Subject: Technical Letter Report with Open
Items for the South Texas Project FSAR Section
2.4.6 Tsunami

**Technical Letter Report
to the U.S. Nuclear Regulatory Commission
JCN Q-4151, Task Order No. 2**

**Technical Evaluation Report with Open Items for the
South Texas Project FSAR Section 2.4.6 Tsunami**

Figure 2.4S.6.4.1-2: Synthetic tsunami time series for the applicant's PNG source scenario at the location indicated in Figure 2.4S.6.4.1-1 ("Buoy Record") from applicant's RAI response (their Figure 18).

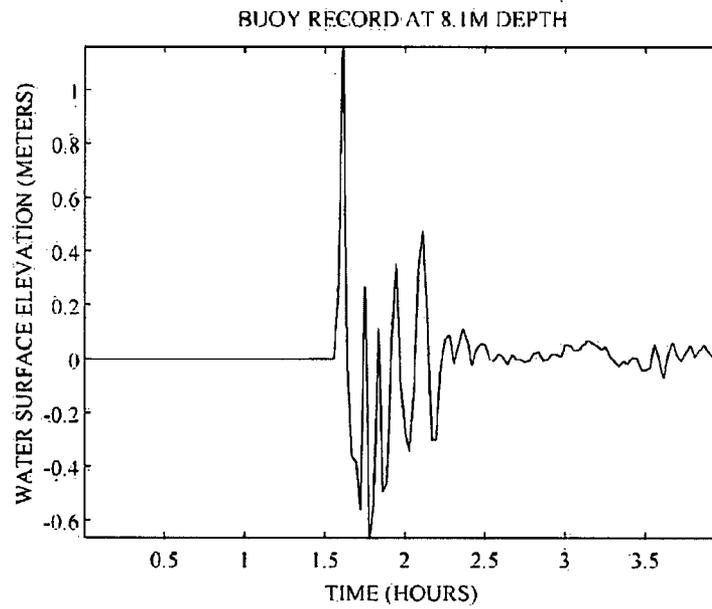
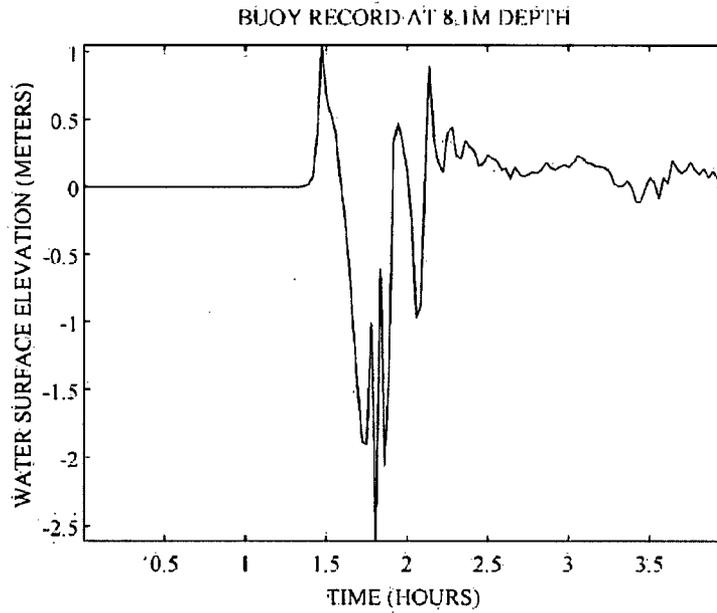
As is evident by comparing Figure 2.4S.6.4.1-2 and Figure 2.4S.6.4.1-3 with Figure 2.4S.6.4.1-4, there is approximately an order of magnitude difference in the maximum wave amplitudes between the applicant's and the staff's estimates (1+ meters versus 10+ meters). It is unlikely that this difference can solely be ascribed to differences owing to the station location and energy dissipation during propagation across the continental shelf. As indicated in Figure 2.4S.6.4.5-8 (1HD propagation) and Figure 2.4S.6.4.5-12 (2HD propagation) there is at most a three-fold reduction in amplitude during cross-shelf propagation, still suggesting a significant difference in the results using the applicant's methodology and our confirmatory analysis. The difference is likely caused by (1) a difference in source parameters; (2) the applicant using a center-of-mass generation model as opposed to our hot-start conditions using a cross-sectional profile of landslide motion and (3) lower bottom friction values used in our confirmatory analysis. For all of these differences, it is likely that the approach used in our confirmatory analysis is more conservative than the applicant's. Tsunami amplitudes decrease greatly during overland flow toward the plant as described in Section 2.4S.6.4.5, using conservative values of bottom friction onshore.

Figure 2.4S6.4.2-2: Excavation photo from applicant's RAI response (their Figure 23).

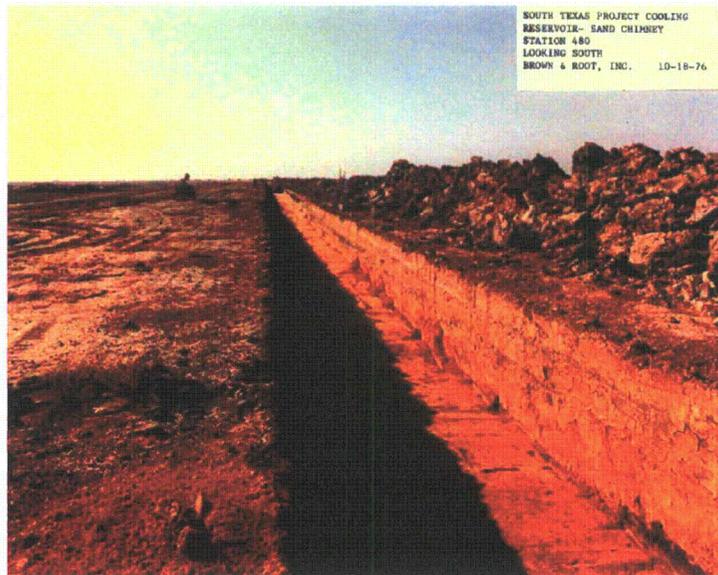
The applicant did not address possible evidence for paleotsunami deposits in the FSAR. In response the RAI 2.4S.6.1-1, the applicant provides three photos of the subsurface geology during excavation of Units 1 and 2. Two of the photos were taken a distance such that the stratigraphy is not discernable. The photo shown in Figure 2.4S6.4.2-2 (applicant's Figure 23 of the RAI response) indicates layers of different sediment: sand, silt and clay (according to the caption of the applicant's RAI response, Figure 23). The applicant indicates that the presence of sand is consistent with deposits emplaced in a "low-energy overbank floodplain adjacent to a meandering and avulsion-based deltaic river system" (pg. 23 of the response). Without additional details of these layers according to the specific sedimentological criteria for identifying tsunami deposits, the

applicant's statement that no evidence of tsunami deposits in these excavations cannot be independently confirmed.
